APPENDIX E – Comments/Responses During Draft EA Review

Teston Road Area Improvements

To: Teston Road IEA Study Team
From: Lynda Mulcahy, Manager Closed Landfill Operations, City of Toronto
Re: Teston Road draft Individual Environmental Assessment (IEA) report comments

Comment #	Reference to Draft EA	Reviewer Comments & Rationale	Review Proposed Action/Solution	Proponent's Response
City of Toronto				
1.	Executive Summary – General	<p>The Executive Summary (and generally the Draft IEA Report) does not acknowledge the potential for landfill gas to be present in the transportation corridor in the vicinity of the 3 closed landfills, and by extension, has not considered this health and safety hazard in the evaluation of options (evaluation of preferred option) for the project.</p>	<p>The project proponent should edit and reconcile the evaluation of options presented in the Draft IEA Report, including the Executive Summary, to acknowledge the potential for landfill gas to be present in the transportation corridor and the associated health and safety hazards, both during the construction period and after the road corridor has been placed into service.</p> <p>The evaluation of the Prefe

DATE: **July 2025** **Figure 7a**

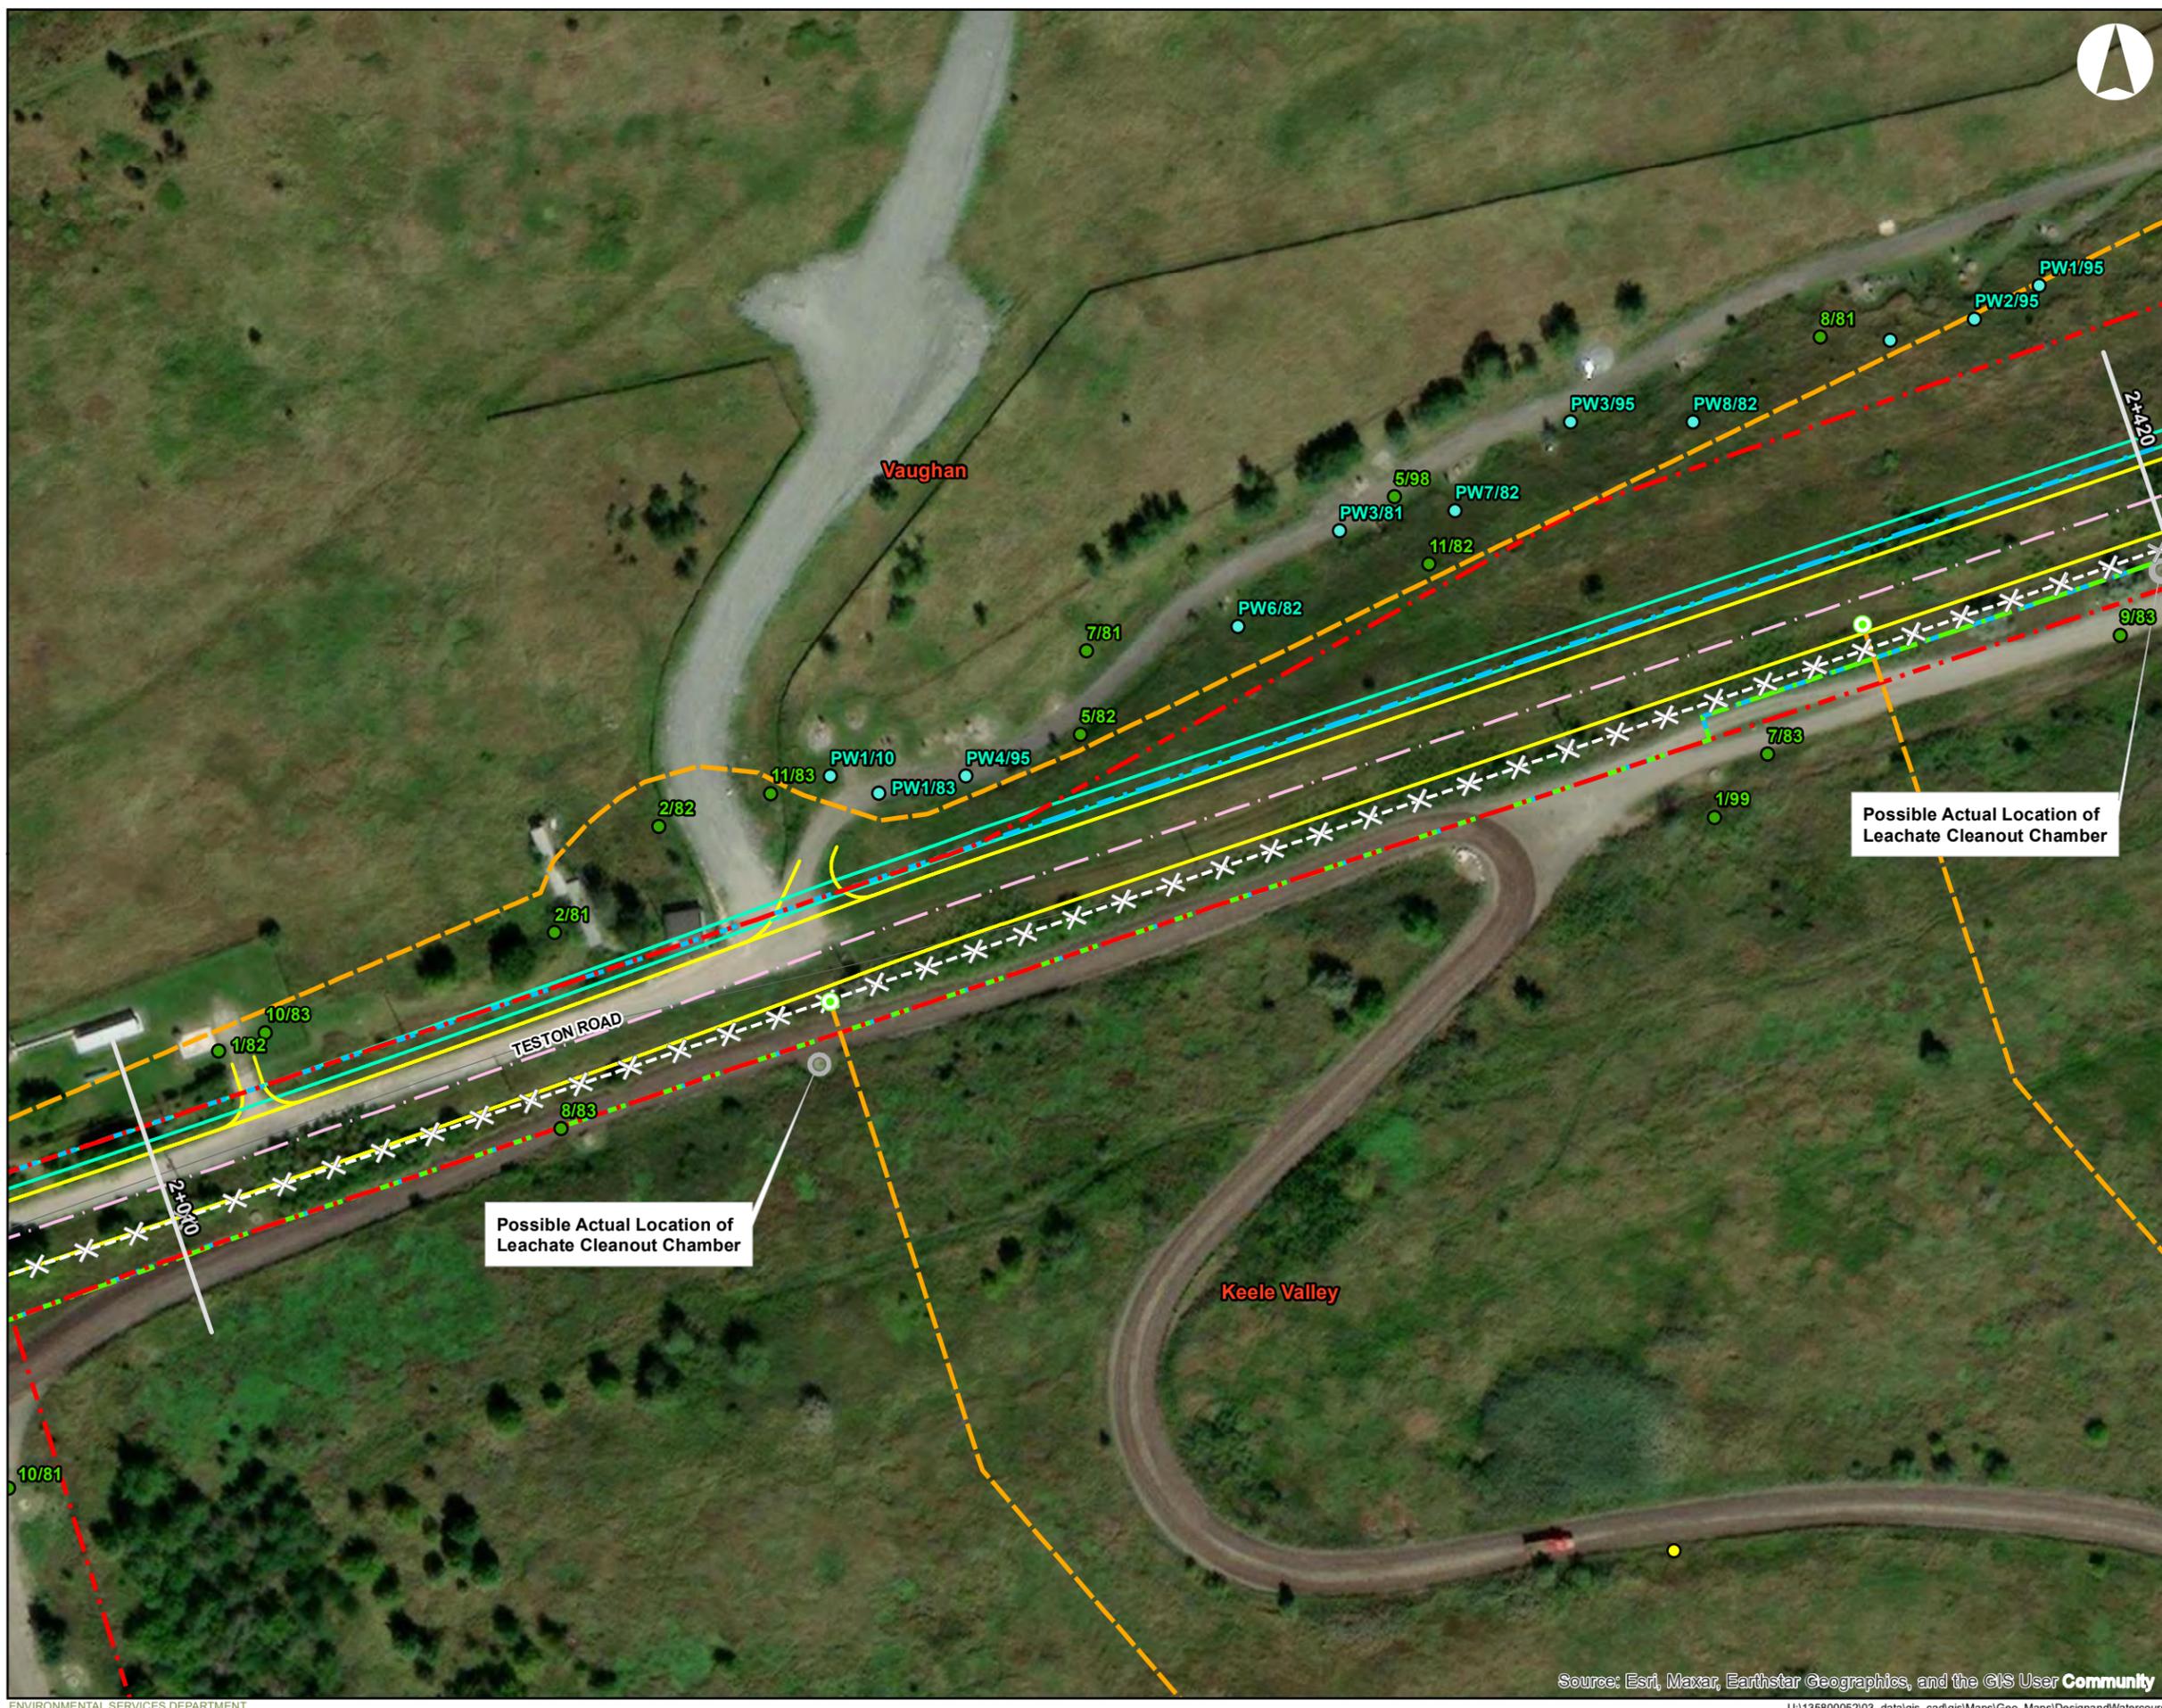
A leachate collection pipe which transmits groundwater impacted by leachate from the TPWS runs beneath the proposed Teston Road in a north-south orientation between 21 Rodinea Road and KVL as shown on Figure 7a (see Attachment #3) and is considered a direct conflict with the proposed road design. This potential impact has been documented in the CEA Report along with a commitment to ensure it is mitigated.
